# UNITED STATES PATENT AND TRADEMARK OFFICE

APPLICATION NO.	FILING DATE	FIRST NAMED INVENTOR	ATTORNEY DOCKET NO.	CONFIRMATION NO.
10/666,493	09/19/2003	Kuo-Tang Hsu	N1085-90162	8017
54657	7590	11/03/2006	EXAMINER	
DUANE MORRIS LLP IP DEPARTMENT (TSMC) 30 SOUTH 17TH STREET PHILADELPHIA, PA 19103-4196			MACARTHUR, SYLVIA	
			ART UNIT	PAPER NUMBER
			1763

## Office Action Summary

FIG. 2a

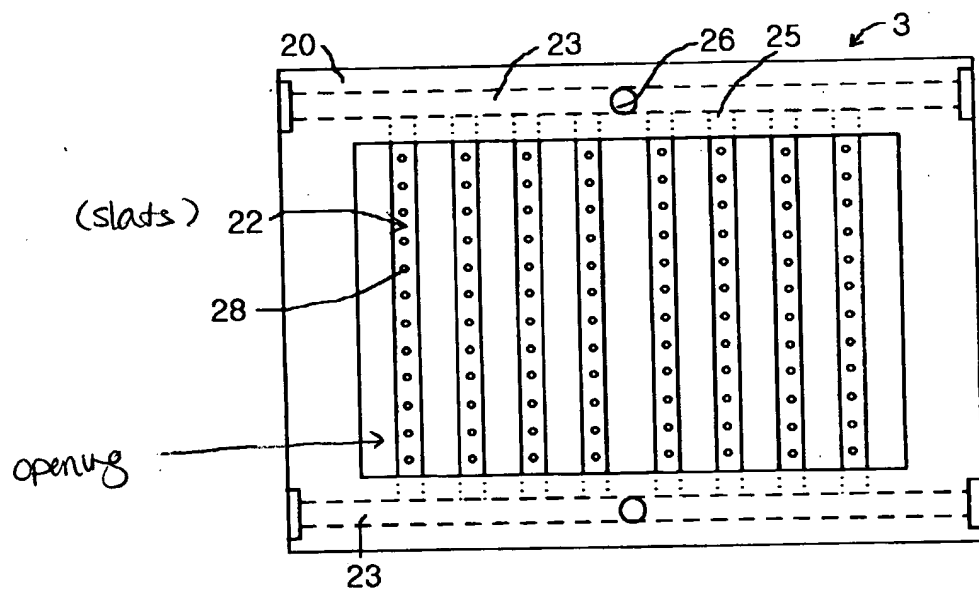
Jeong teaches a tank 1, a drain opening 18, and a bubbling plate 3(interpreted as the regulating means) comprising slats 22 and openings, see Fig. 2a. The bubbling plate 3 of Jeong performs both supply (pipe 8) and draining (pipe 18) of the process fluid. During draining fluid in the tank flows from the processing region (area above the bubbling plate) through the bubbling plate through the draining region (area under the bubbling plate) and out the drain to control the draining rate and downward direction of the fluid. The recitation of the use of bubbling plate is to prevent sticking is a matter of an intended use.

Regarding claims 1, 10, and 18: Jeong teaches a tank 1, a drain opening 18, and a bubbling plate 3(interpreted as the regulating means) comprising slats 22 and openings, see Fig. 2a. The examiner has provided a marked-up copy of Figs. 1 and 2a for applicant's convenience.

Regarding claim 7: Jeong teaches that the bubbling plate comprises slats and openings see Fig. 2a.

The apparatus of Jeong teaches a tank with a drain 18 and a bubbling plate. Fig. 2a illustrates the vicinity of the bubbling plate (interpreted as the regulation means). The bubbling plate of Jeong controls the flow of fluid both supplying (upward flow through pipe 8 and downward flow through 18).

FIG. 4

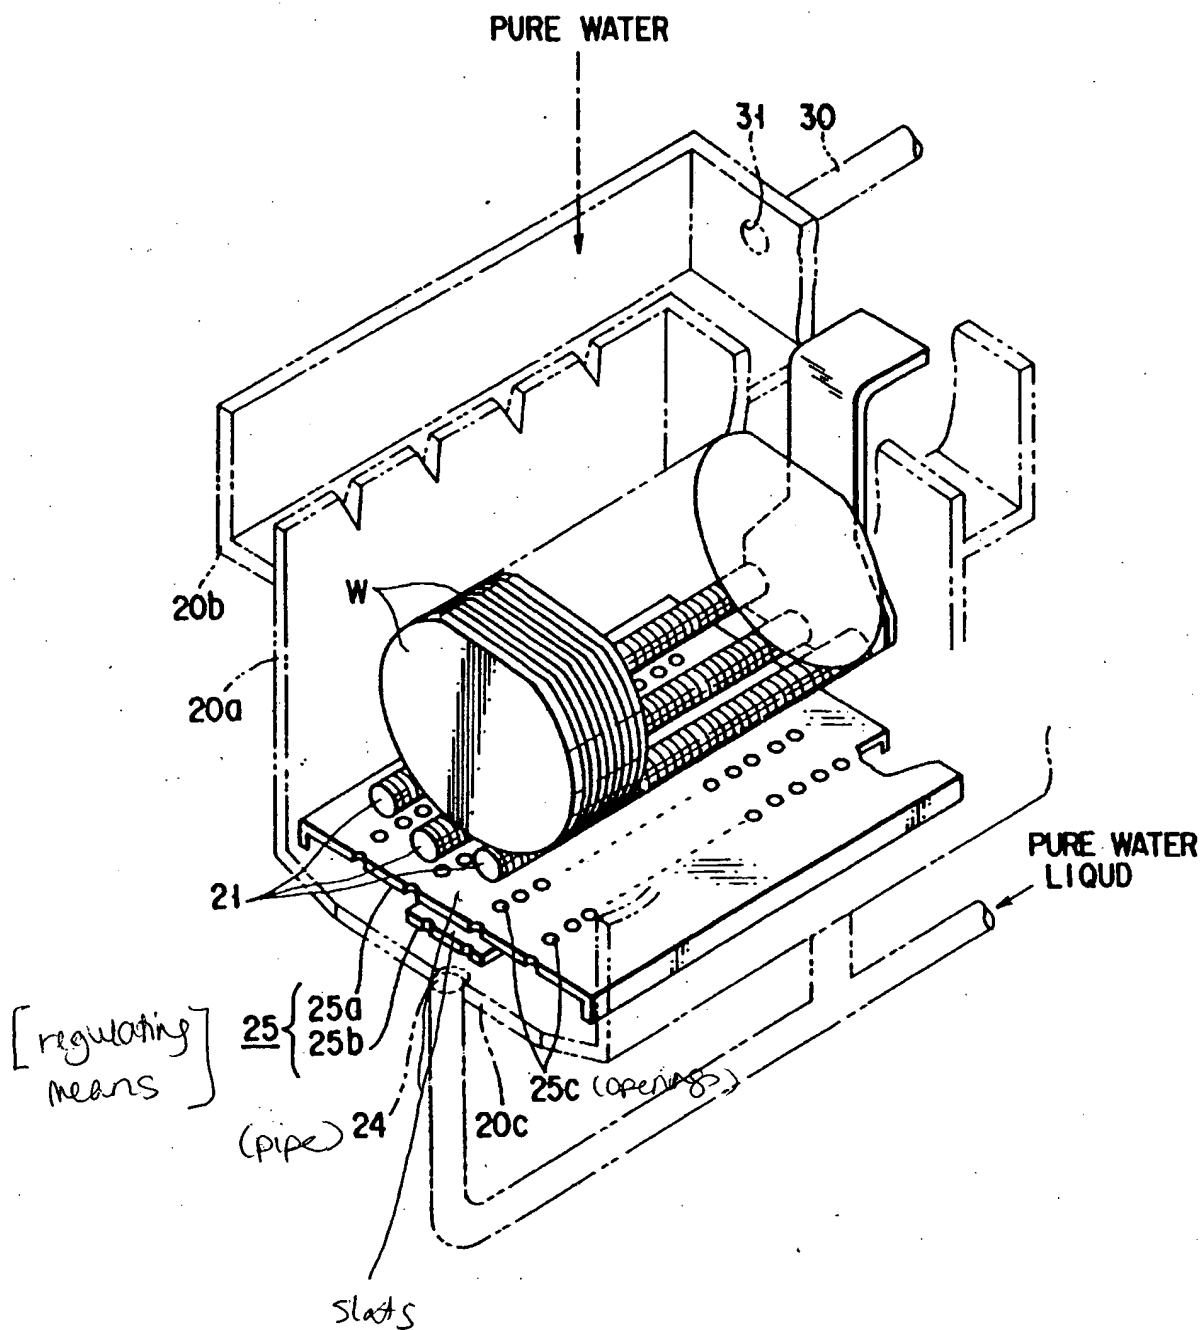
Shindo et al teaches a substrate washing and drying apparatus wherein a tank is provided with a regulating means 25 comprising slats (solid material of the plate) and openings. Fig. 4 illustrates that at least one of the slats covers pipe 24. Note that the slats of Shindo are wider while the openings are smaller.

Shindo et al illustrates the vicinity of slats (non-perforated material) over pipe 24. The illustration in Fig. 4 shows a slat covering the pipe.
